# Technical Service Bulletin

<b>Subject:</b> <b>AIR CONDITIONER DOES NOT BLOW COLD AIR DUE TO CRACKED COOLER PIPE (HI) A (REFRIGERANT LEAK)</b>	<b>Bulletin No.:</b> 07-004/18
	<b>Last Issued:</b> 08/01/2018

Location of cracking

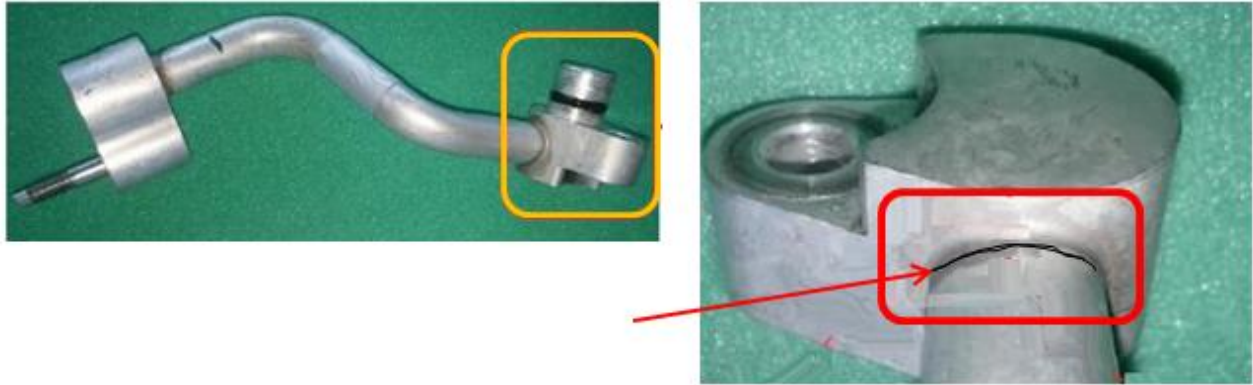
Some vehicles may experience that the A/C does not blow cold air (blows warm air) due to a refrigerant leak. This is caused by a crack in the cooler pipe (HI) A (1) due to engine vibration. To correct this issue, the material and thickness of the cooler pipe (HI) A has been changed to increase durability.

(1)	Cooler pipe (HI) A
(2)	A/C compressor

(3) Condenser

1. Verify customer concern.
2. Inspect the cooler pipe (HI) A.
  - If the cooler pipe (HI) A is cracked, replace the cooler pipe (HI) A with a modified one according to the instructions on MGSS (REFRIGERANT LINE REMOVAL/INSTALLATION).
  - If the cooler pipe (HI) A is not cracked, this TSB is not applicable. Refer to troubleshooting procedure on MGSS (NO COOL AIR [CLIMATE CONTROL SYSTEM]).
3. Verify repair.
